ADDENDUM NUMBER SEVEN

RFQ # 7449435

TITLE: RENOVATIONS TO THE ART CENTER AT RI COLLEGE

**Art Center Renovation – Rhode Island College
600 Mount Pleasant Avenue
Providence, Rhode Island**

REVISION TO DRAWING A9.4

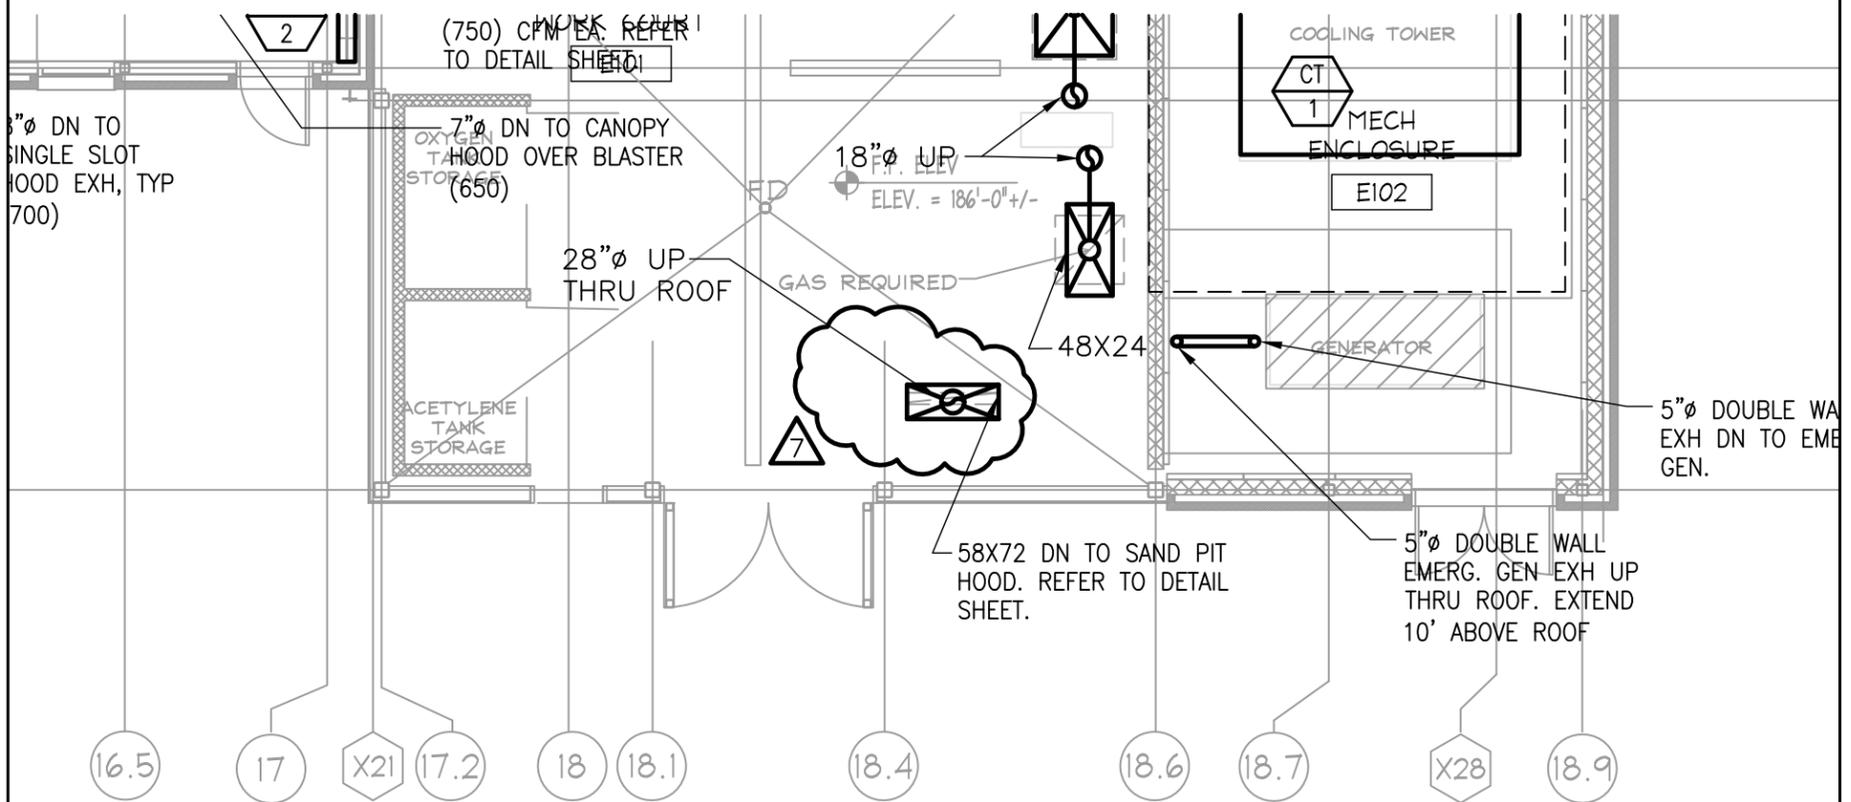
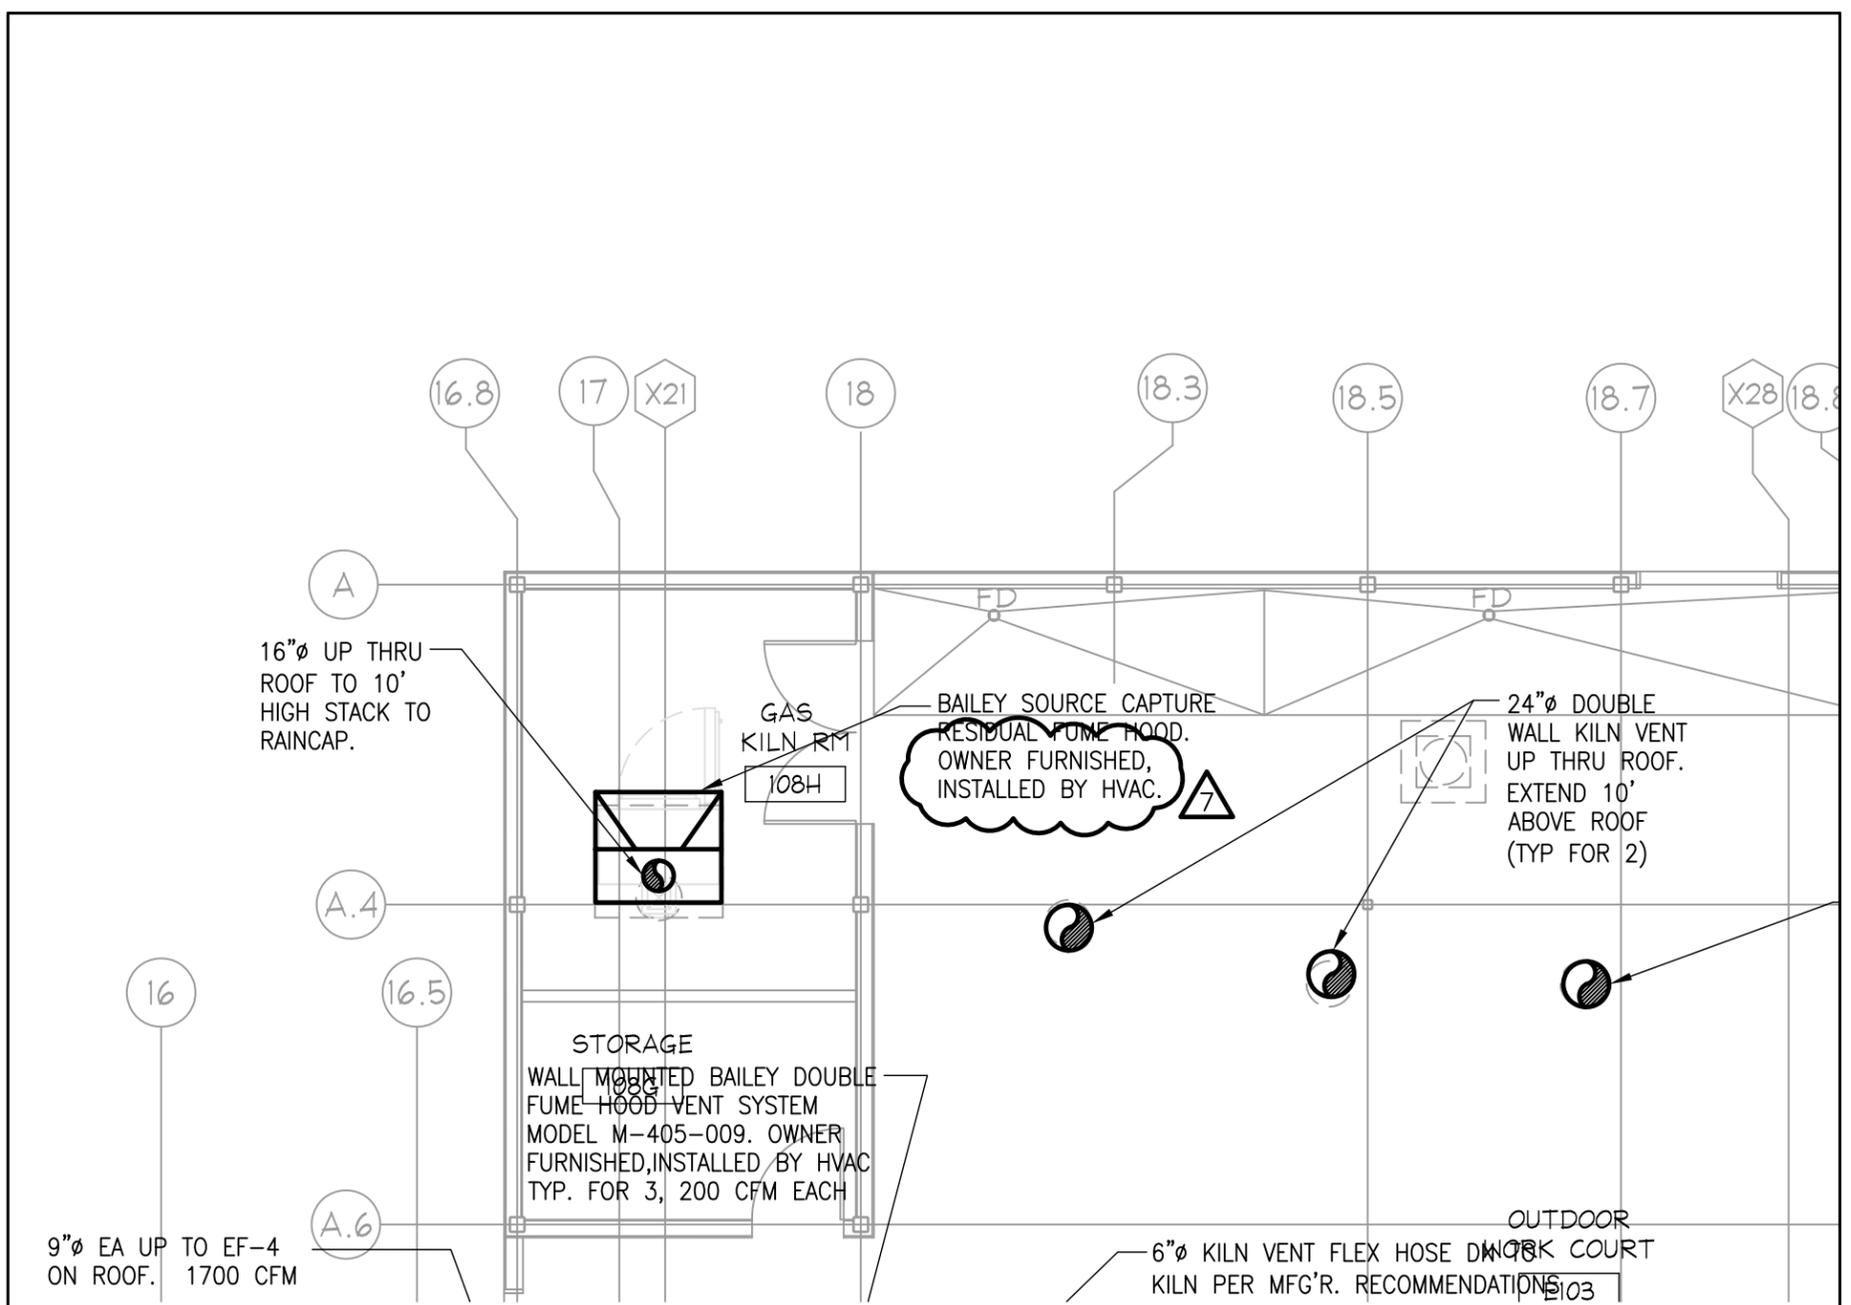
- ITEM 1:** Add detail 20 Sand Pit Section & add detail 21 Sand Pit Plan. See SKA-A-088.

REVISION TO DRAWING H2.1

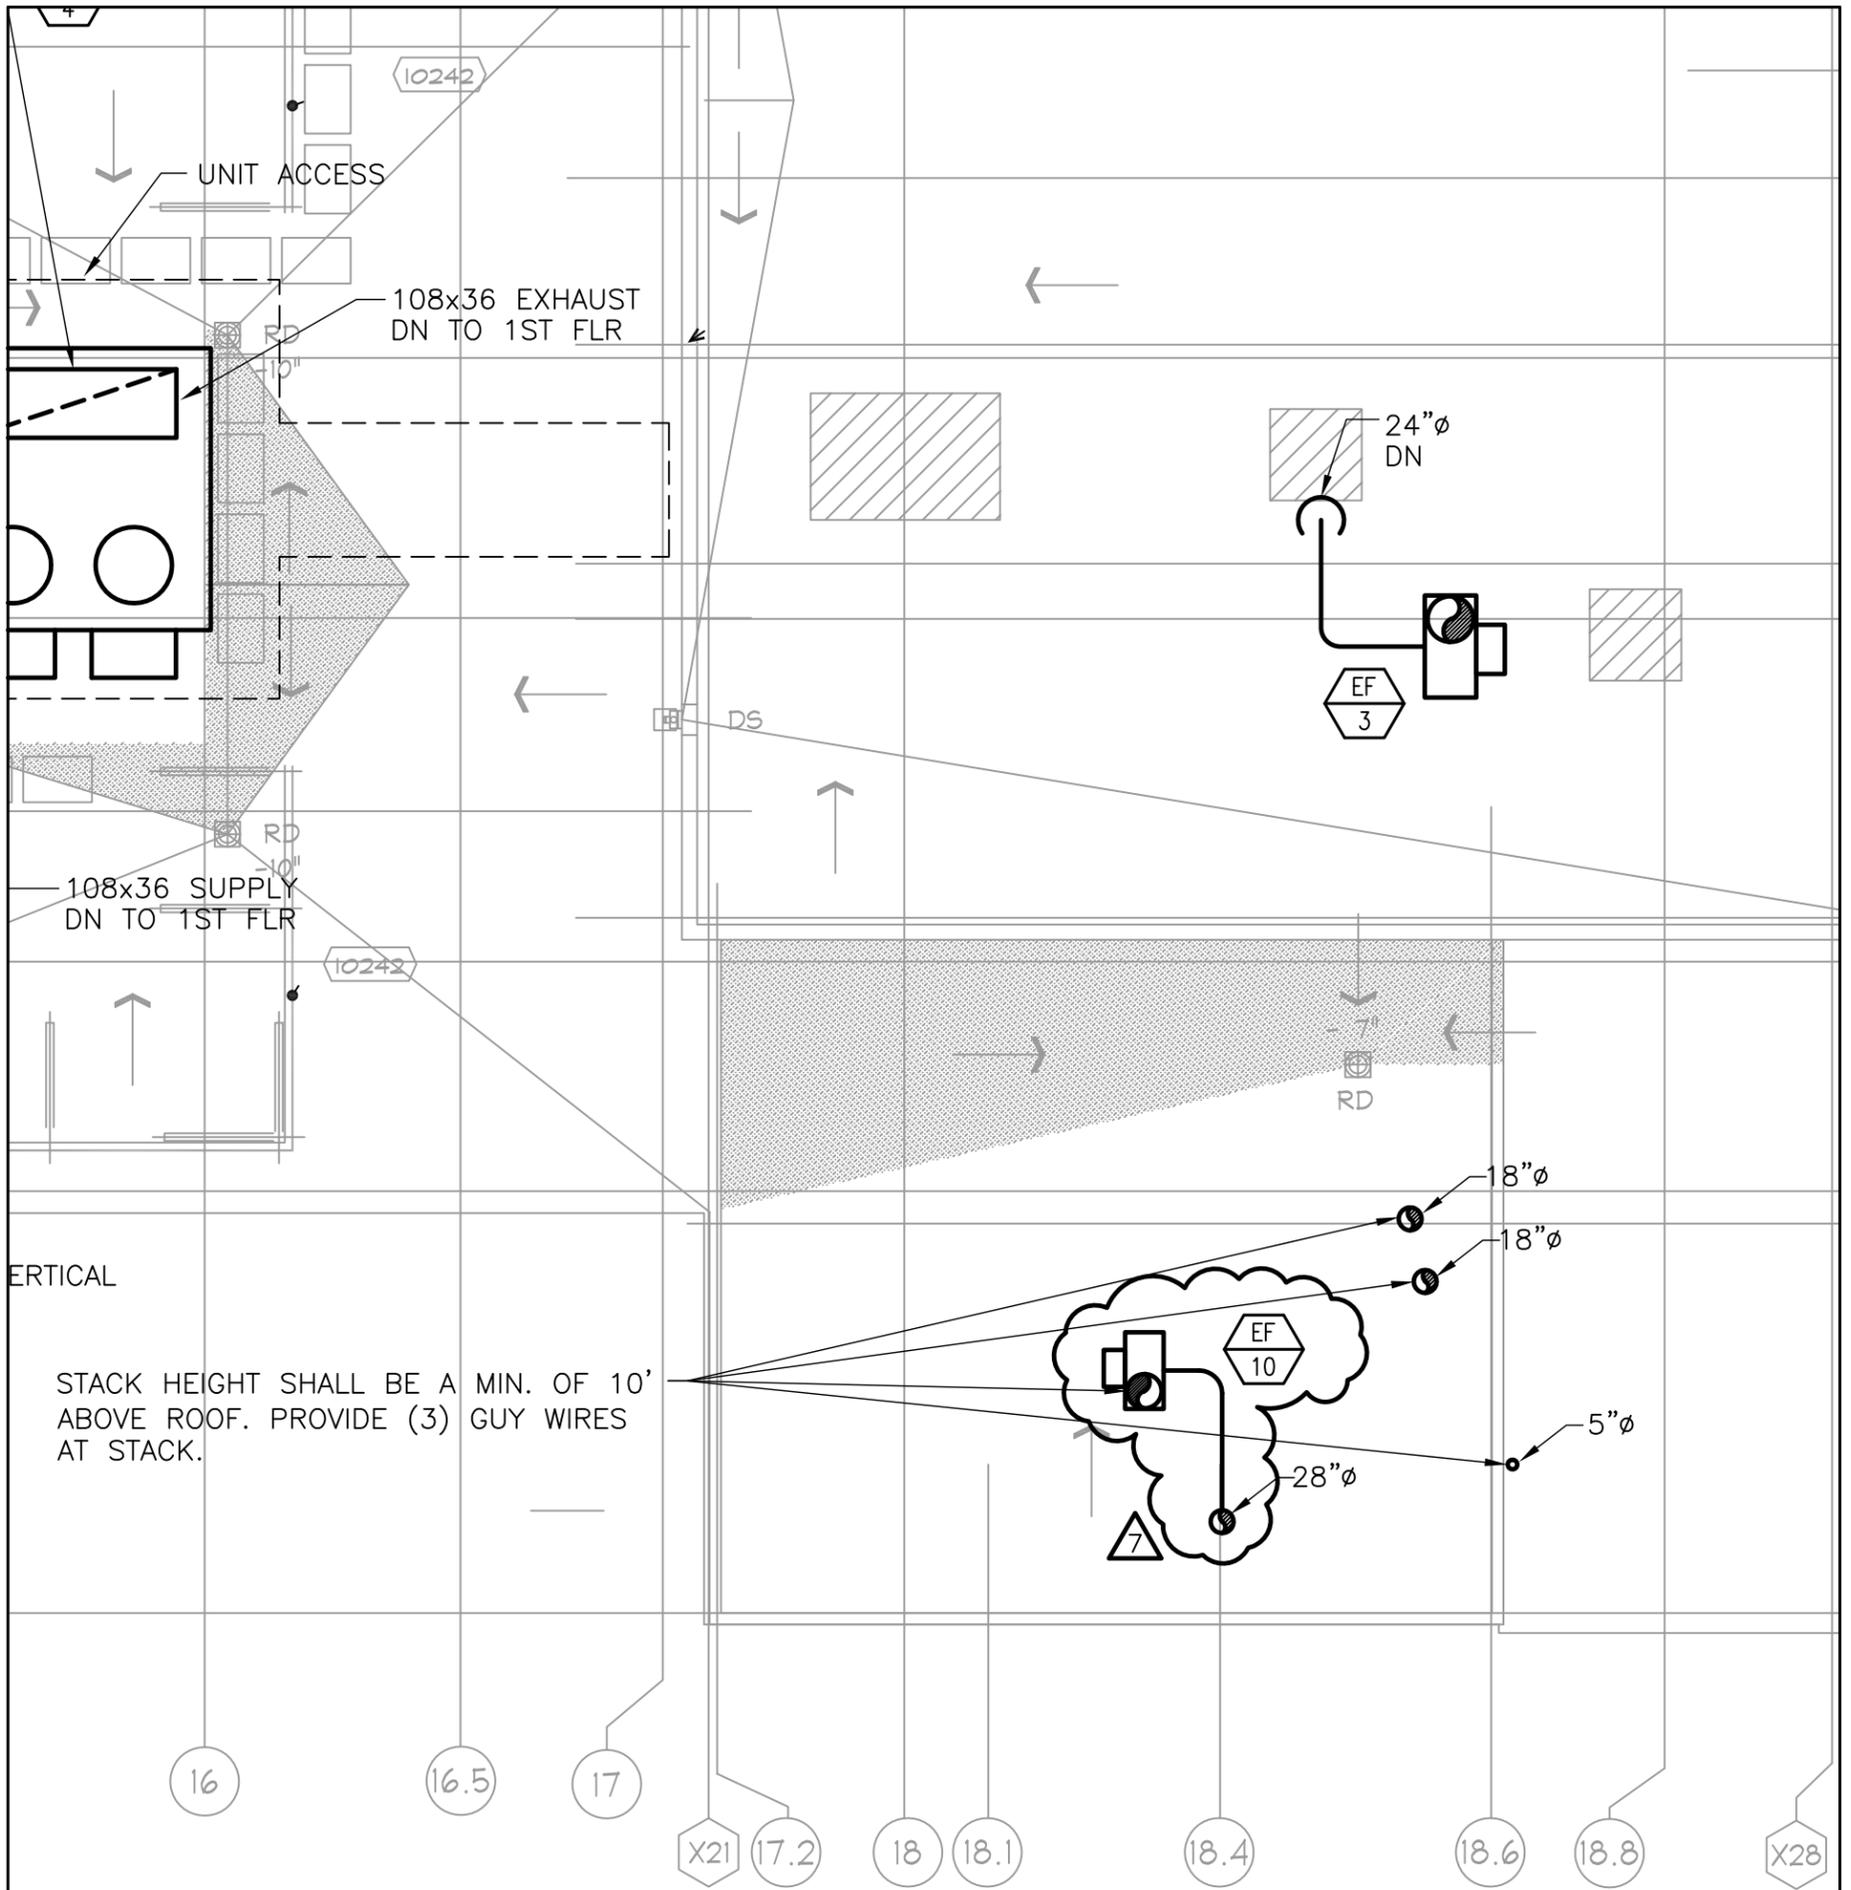
- ITEM 1:** SKA-H-023 – Clarification to the First Floor Ductwork Plan, Dwg. H2.1.
ITEM 2: SKA-H-024 – Clarifications to the Roof Plan, Dwg. H2.3
ITEM 3: SKA H-025 – Changes to Exhaust/Supply Fan Schedule, Dwg. H8.2.
